SERVICE BULLETIN

PURPOSE : INFORMATION	ISSUE NO. : MSB-10E35-008	DATE : 2010-11-05
SUBJECT : ABS AND ASC TROUBLESHOOTING		<MODEL> (EUR) OUTLANDER (CW0W)
GROUP : ANTI-SKID BRAKING SYSTEM (ABS)/ ACTIVE STABILITY CONTROL SYSTEM (ASC)		<M/Y> 07-11

Troubleshooting procedures for the ABS and ASC are changed in the applicable Workshop Manuals. This Service Bulletin contains the modified descriptions.

Attached sheet 49

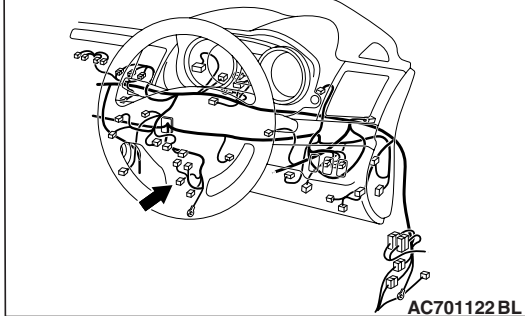
<Added>

PROBABLE CAUSES

- Wiring harness or connector failure for the special CAN bus lines between ASC-ECU and the G and yaw rate sensor
- G and yaw rate sensor malfunction
- ASC-ECU malfunction
- External noise interference

Attached sheet 51

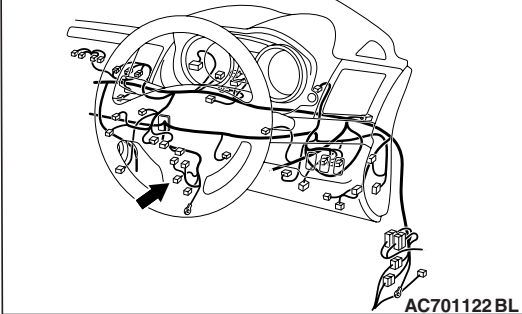
<Added>

PROBABLE CAUSES

- Wiring harness or connector failure for the special CAN bus lines between ASC-ECU and the G and yaw rate sensor
- G and yaw rate sensor malfunction
- ASC-ECU malfunction
- External noise interference

STEP 6. CHECK ETACS CODING DATA

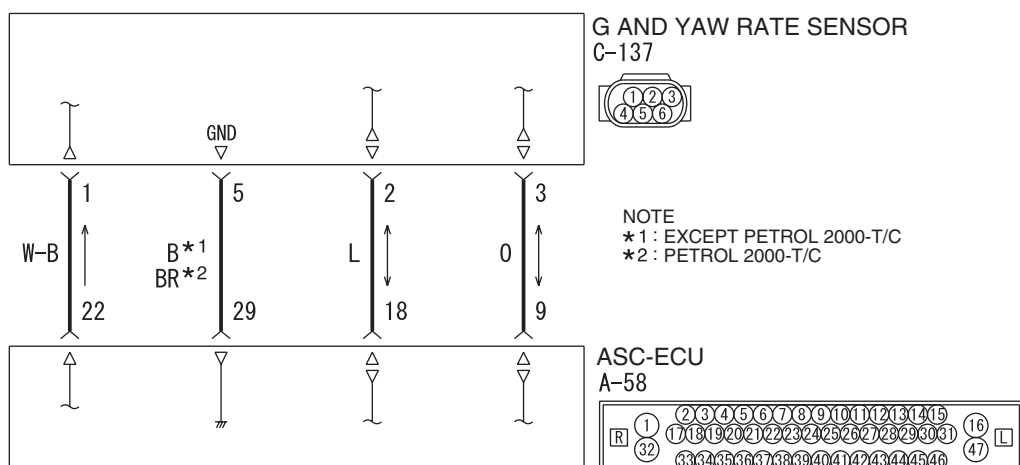
<Old>

ESS**OK: PRESENT****Q: IS THE CHECK RESULT NORMAL?****YES :** Go to Step 8.**NO :** Go to Step 7.**STEP 7. ETACS-ECU CODING DATA CHECK**

Q: IS THE CHECK RESULT NORMAL?**YES :** Go to Step 8.**NO :** Replace the ETACS-ECU (Refer to GROUP 54A – ETACS-ECU), and then go to Step 11.**STEP 8. CHECK THE ASC-ECU POWER SUPPLY CIRCUIT.**
